INCH POUND
MIL-STD-1320/165(OS)
NOTICE 2
30 SEPTEMBER 1988

TRUCKLOADING OF HAZARDOUS MATERIALS
GUIDED MISSILE, AGM-45 OR 45B (SHRIKE)
IN CONTAINER CNU-167/E FLEET ISSUE UNIT LOAD

MIL-STD-1320-165 (NAVY) NOTICE 1 20 January 1976

TRUCKLOADING OF HAZARDOUS MATERIALS

UNIT LOAD DATA

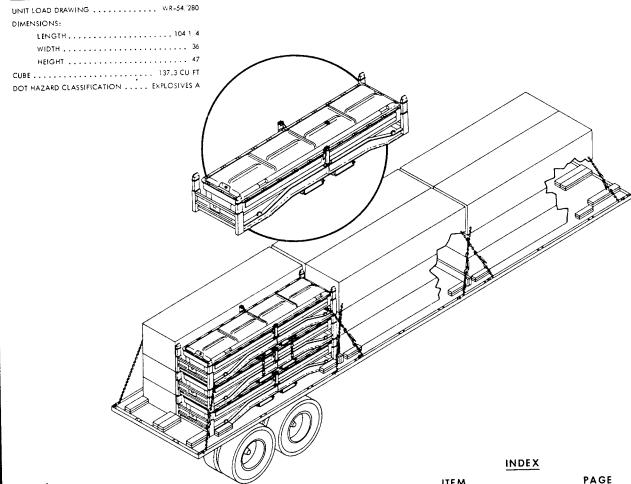
1. IN UNIT LOAD DATA, CHANGE DIMENSION "L-----104 1/4" to "L-----140 13/16"
